VOLVO

servicetips

ISSUE C1-72

Fig. 1. Wiring diagram

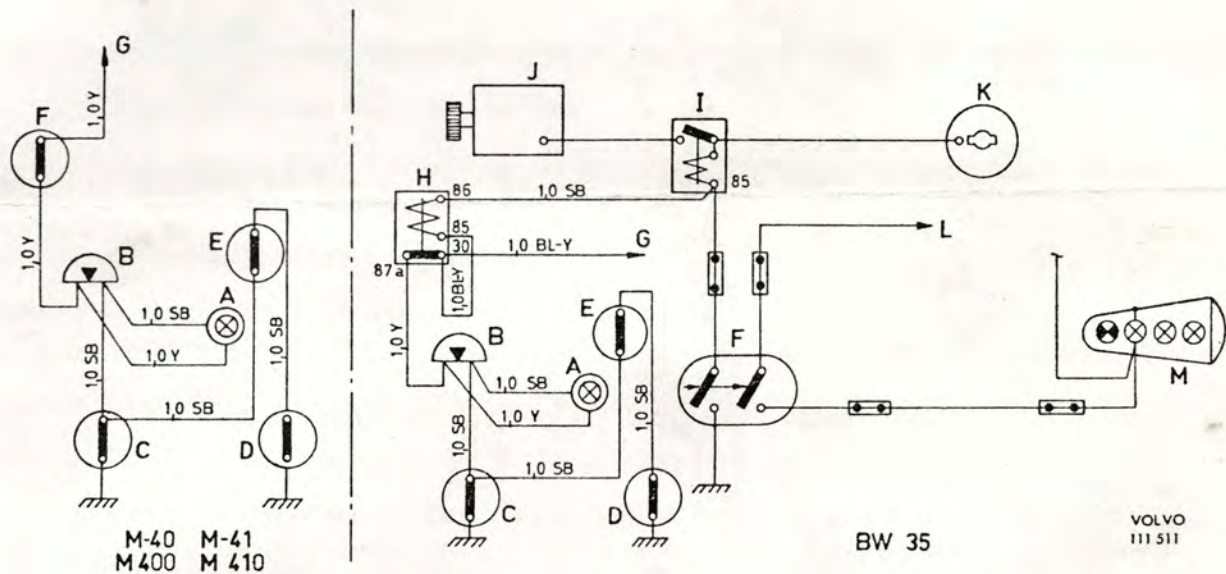
From March, 1972, our cars are being fitted with seat belt reminders. These are in the form of a warning lamp and a warning buzzer.

The adjacent diagram shows how the different components are wired up electrically. However, the diagram does not apply to vehicles with the BW 35 transmission.

On the 140 and 164, the warning lamp and buzzer are wired to fuse 3. On 1800 E/ES, they are wired to fuse 6.

Mention was made of the new belt reminders earlier in this edition of Service Tips. It now happens that personnel who transport new cars daily are irritated by the buzzing sound and for this reason the belt reminder buzzer is disconnected in all vehicles before shipment. You are therefore requested to check that the belt reminder really functions and where necessary to connect the ground cable under the belt lock before the car is delivered to the customer.
